SERVICE BULLETIN - OPTIONAL

Part No.: LS600-20x Loudspeakers

ECO No.: ECO1225

Subject: Re-entrant Tip Securing (MOD 4)

Figure 4 – Old Doubler Plate Removal

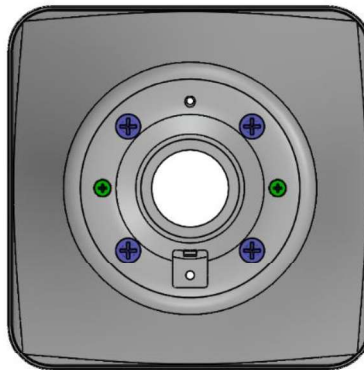
- 2.2.1 Per Figure 4, remove two #2 Phillips Screws (shown in green) and four #3 Phillips Screws (shown in blue). Remove and discard Doubler Plate and all screws. Remove old Threadlocker from threads.

Figure 5 – New Doubler Plate Installation

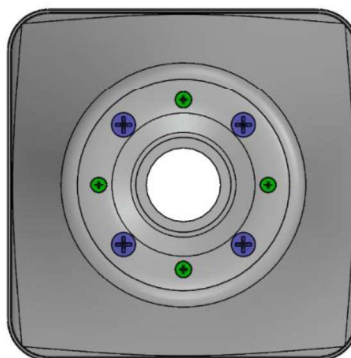
- 2.3.1 Place new Doubler Plate (150-08-035) inside the bell and align its holes with the holes in the bottom of the bell.
- 2.3.2 Per Figure 5, apply LOCTITE® 271 to four #3 Phillips Screws (shown in blue) and torque to 30 in-lb. Torque four #2 Phillips Screws (shown in green) to 9 in-lb. Do not apply LOCTITE® 271 #2 Phillips Screws.

Note: LOCTITE® 271 sets in 10 minutes and fully cures in 24 hours.

Figure 7 – LOCTITE® 222 Locations for Re-Entrant Tip Replacement

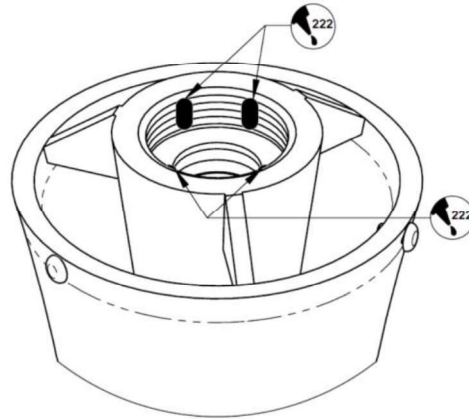
- 2.4.2 Per Figure 7, apply four thin strips (approx. 0.25" wide) of LOCTITE® 222 to Re-Entrant Tip threads.

Note: LOCTITE® 222 sets in 10 minutes and fully cures in 24 hours.
